Ref:- Base Infrastructure Works Project Under The Security Improvement Program - SIMPSON  
BARRACKS - Macleod, Victoria 3085

This submission requests that the decision for the construction of the proposed new island and entry point at Yallambie Road, Macleod, be deferred until a further examination of other potential solutions are more thoroughly assessed.

MAP 1(A)

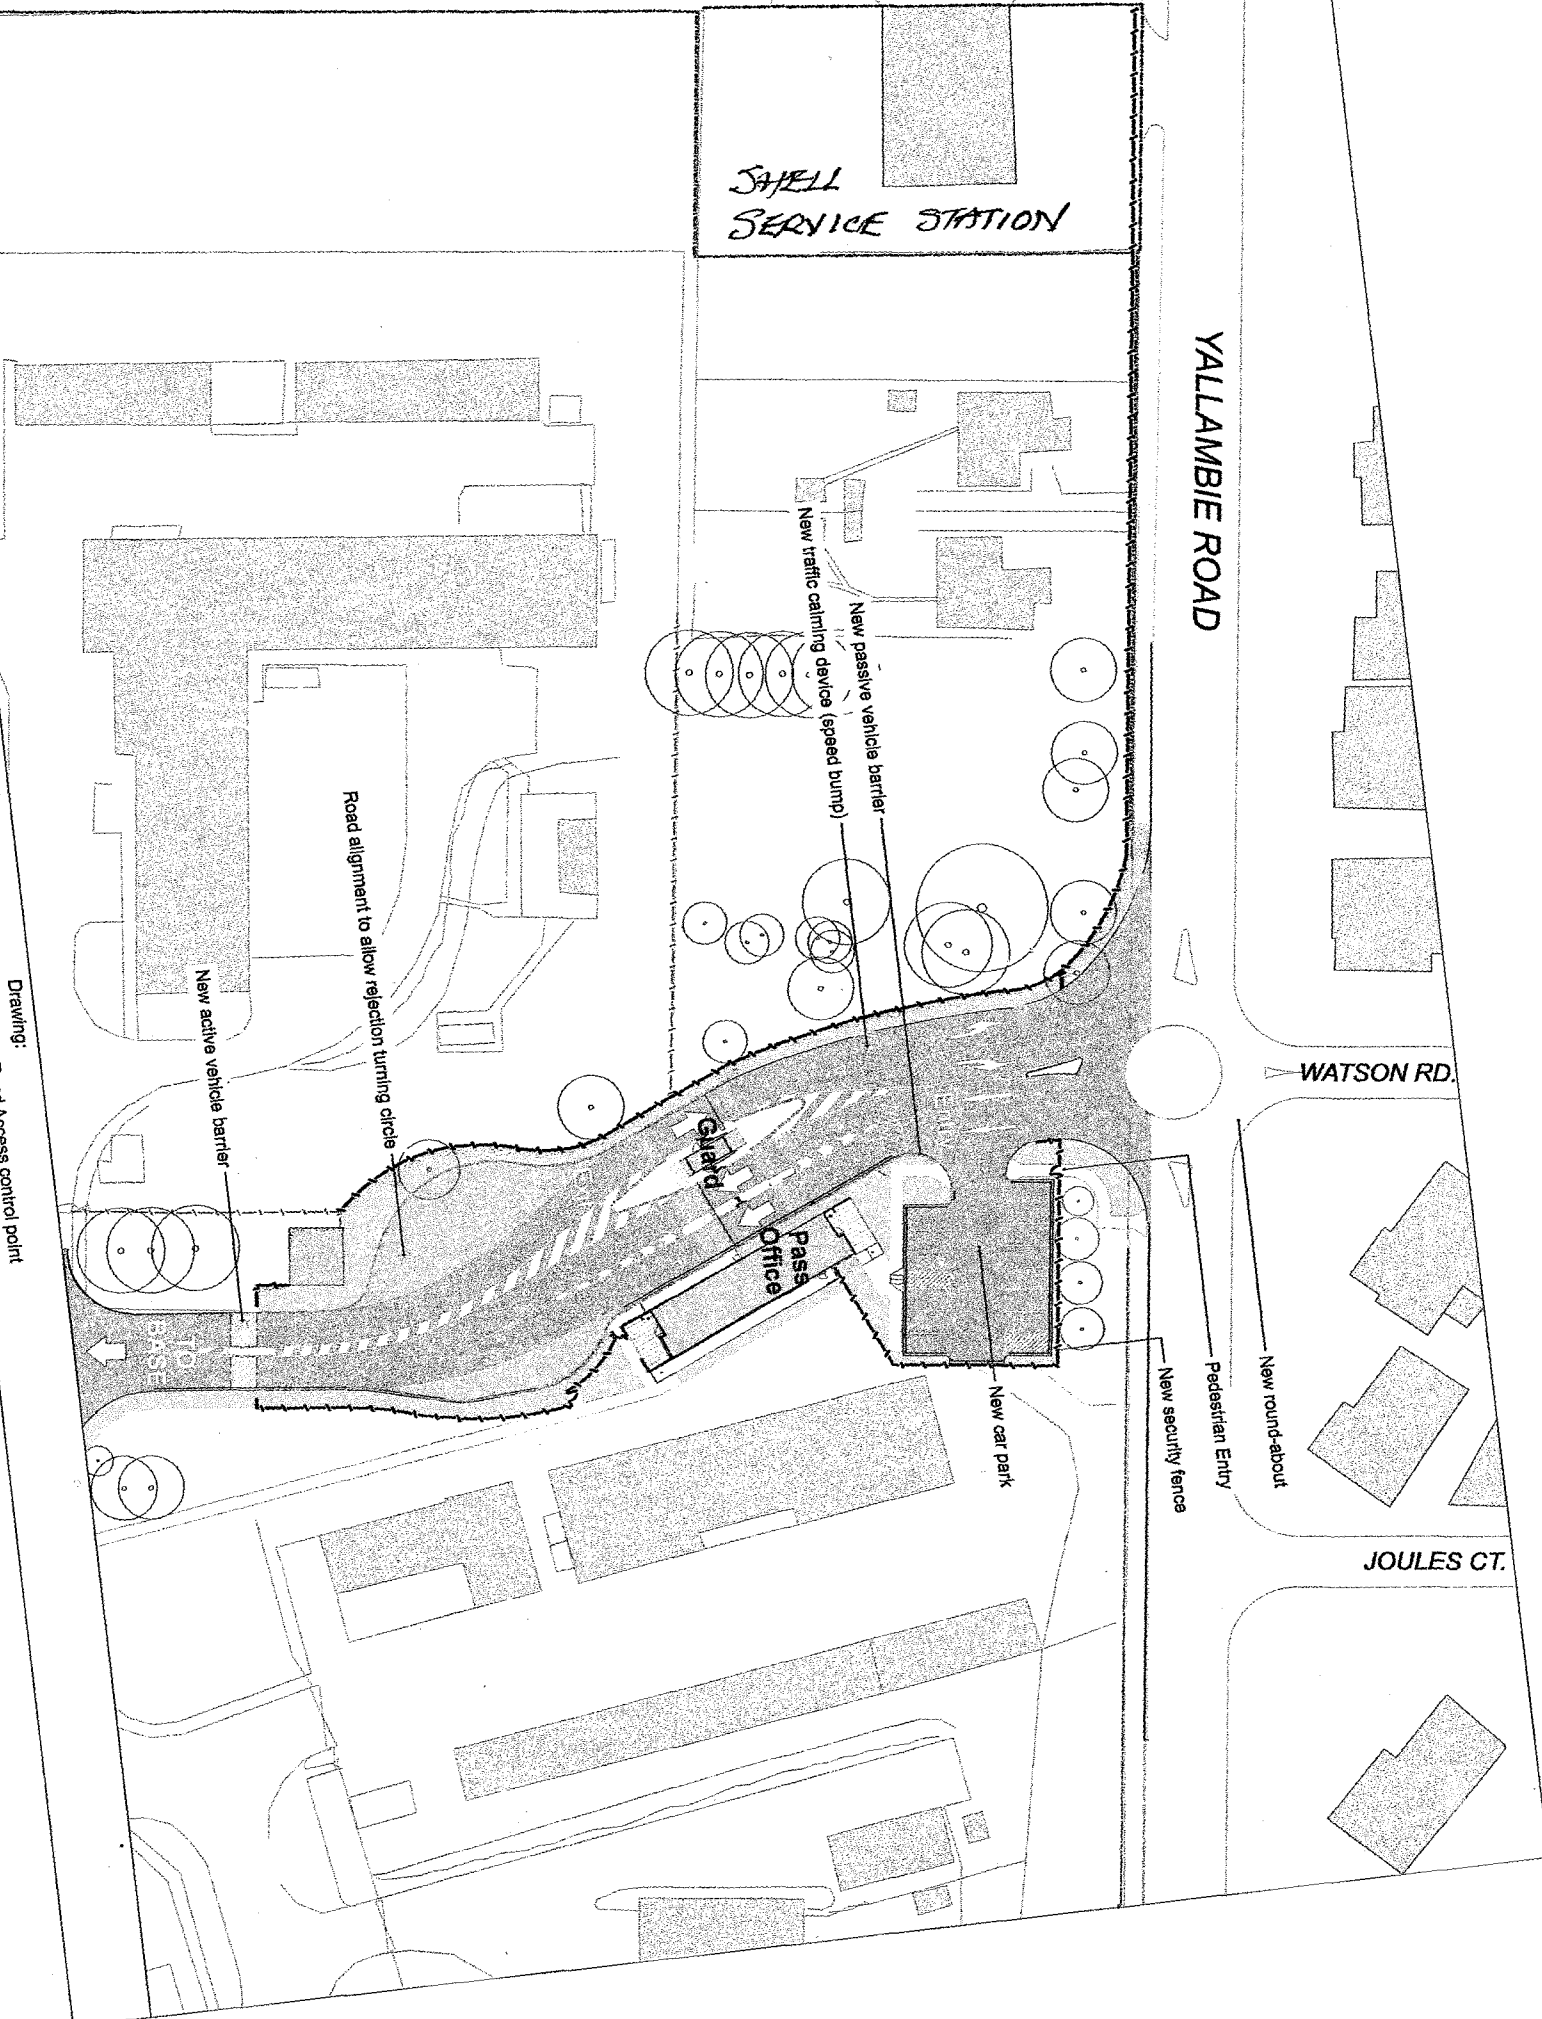
Since the distance from the intersection to the proposed island and entrance, as can be seen by referring to Map 1 and 1A, is only 114 metres, traffic delays (which are already occurring) will be considerably increased.

MAP 2

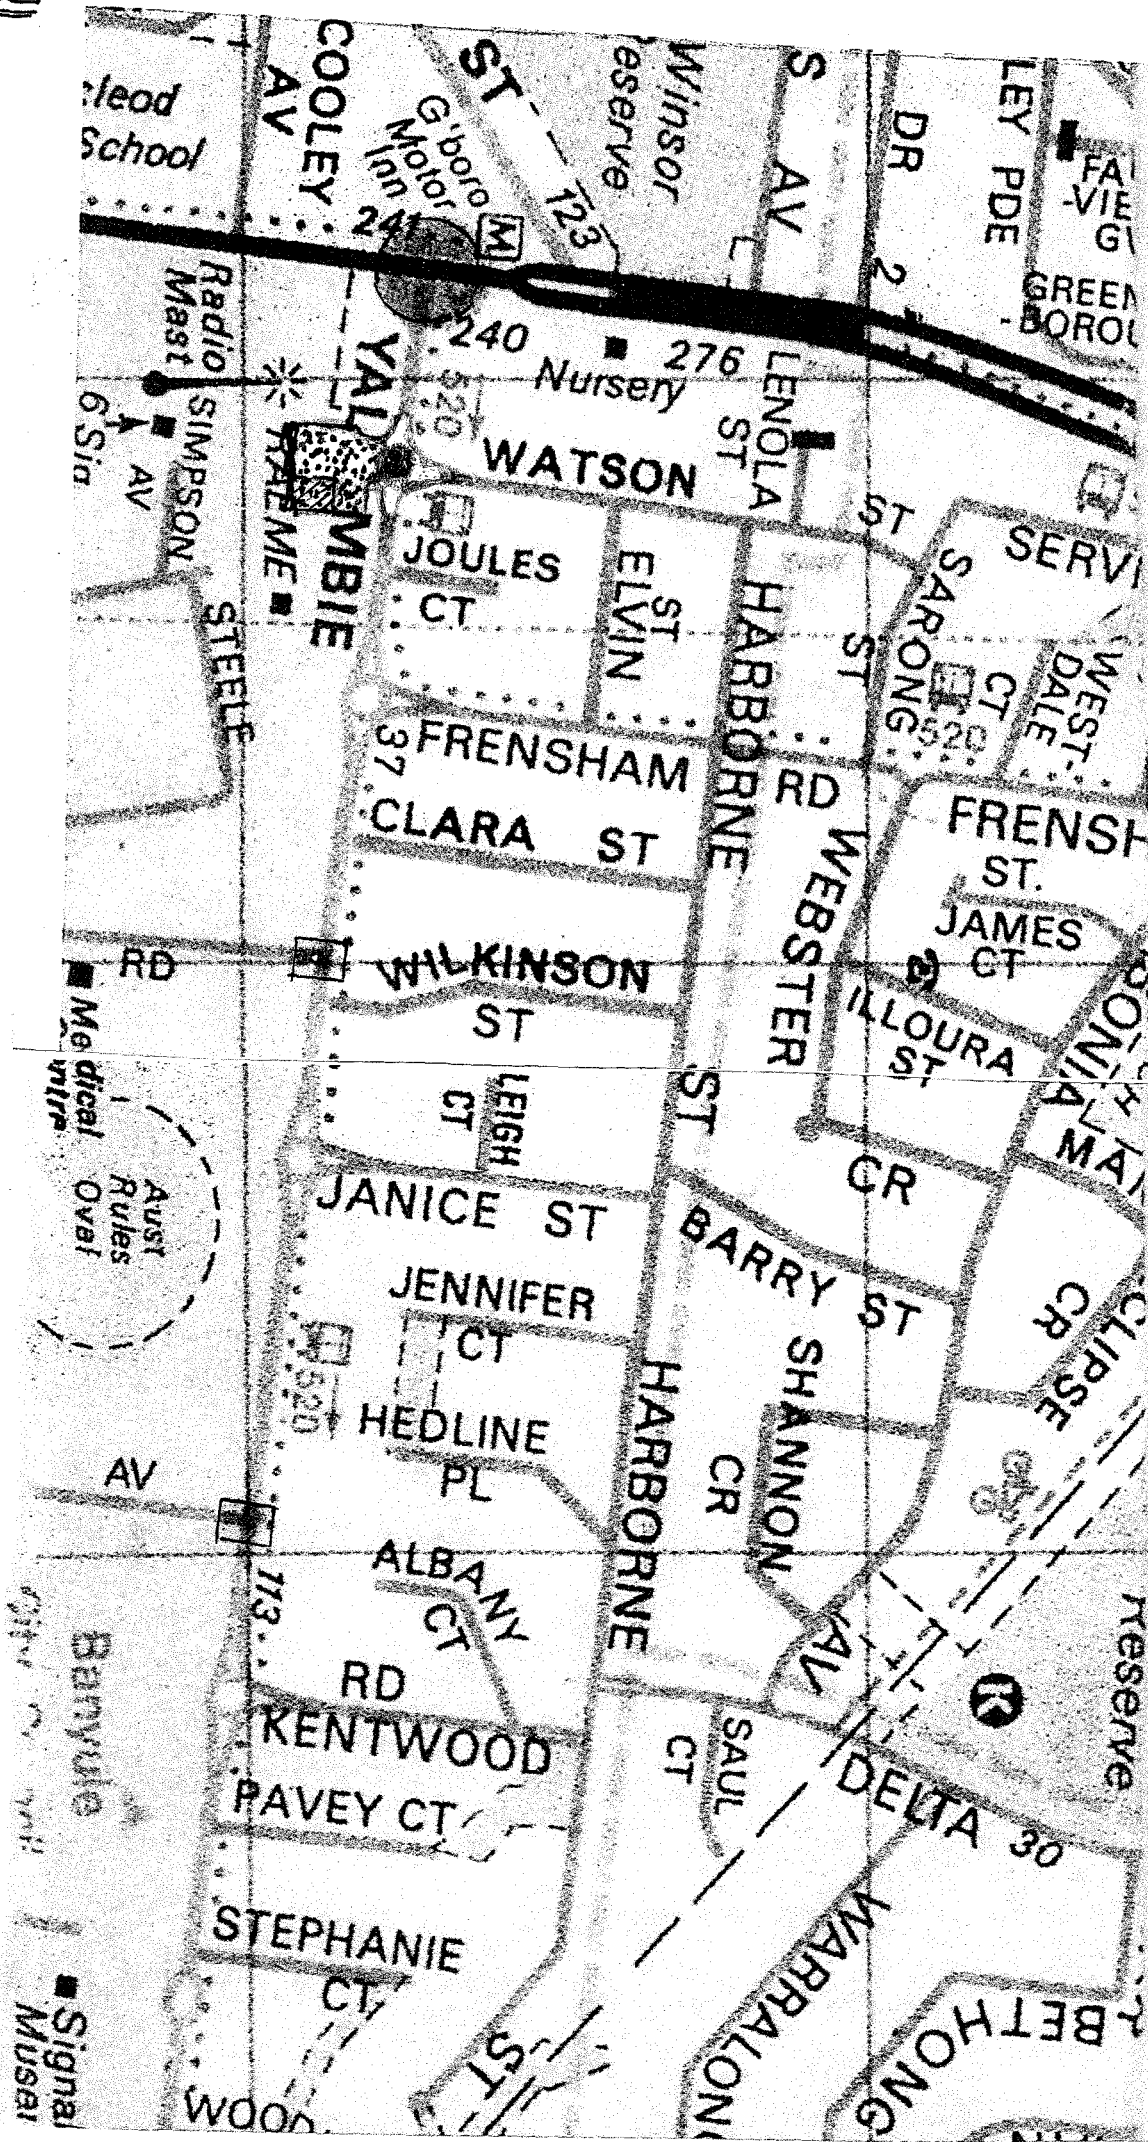
There are at least two more effective and less disruptive locations for a new entry point, which can be referred to on Maps 2 and 3.

1. The two existing entrances on Yallambie Road, either or both of which, could be used for entrance and exit to the Barracks. An additional island, very close to the main intersection at Watson Street would then no longer be required. This would allow for a smoother flow of traffic to and from the intersection at Greensborough Highway, as well as the dispersal of traffic into the side roads off Yallambie Road.
